Memorandum

Re: Denton Acres Zoning Petition
SBL# 42.15-1-1

Date: June 3, 2024

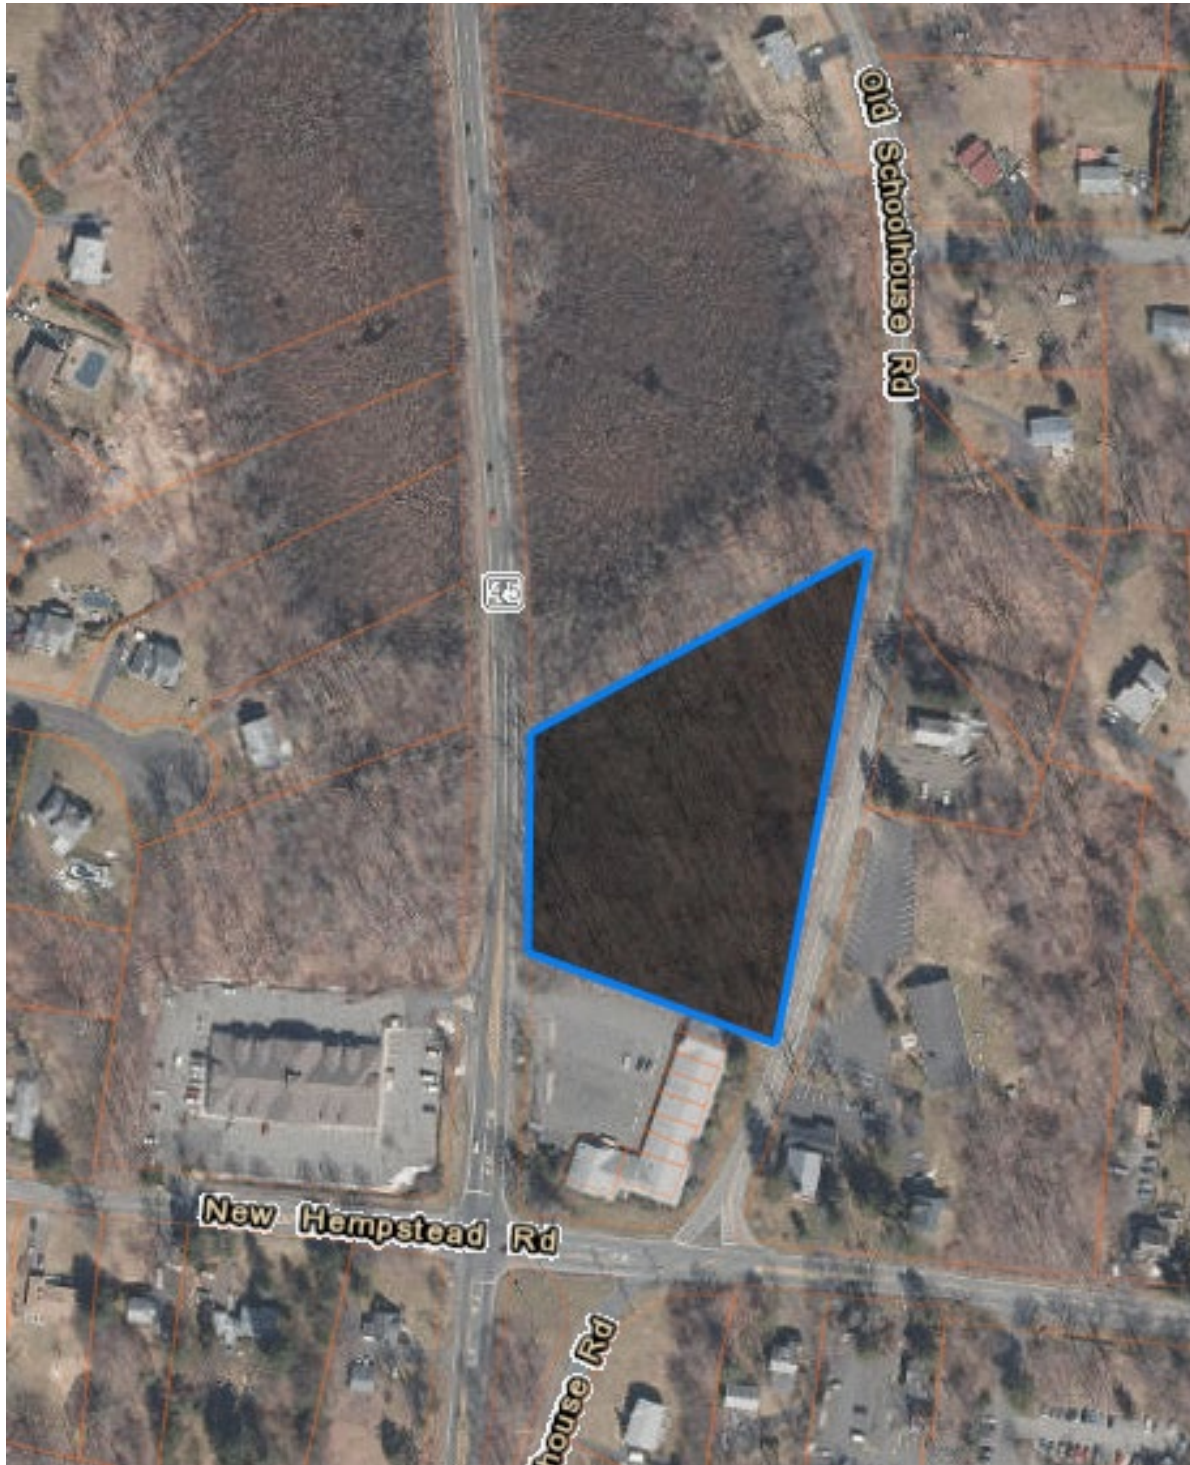
- c. Parking should be shown on the plan meeting the standards of §290-62.B. **This comment is not resolved.**
7. The entirety of the petitioner’s premises (lot 42.15-1-1) is requested for rezoning. If this petition is considered, the Trustees may wish to consider only designating the NCD District on just the three acres outside of the wetland and its associated state-required buffer, rather than rezoning the whole premises including the wetland itself which is unbuildable, and the adjacent 100 foot buffer of the wetland, which is highly regulated by the New York State DEC and Village Code Chapter 159, Freshwater Wetlands. (See figure on page 4.) **This comment is not resolved.**

Location of subject lot between NYS 45 on the west side, and Old Schoolhouse Road on the east side. The site would take access from Old Schoolhouse Road, across the street from Village Hall, because of the large state regulated wetland and buffer on the northwest side.

The Trustees may wish to consider limiting the proposed NCD zone to the portion of the site outside of the State-regulated wetland and its regulatory buffer zone. See comment 7.
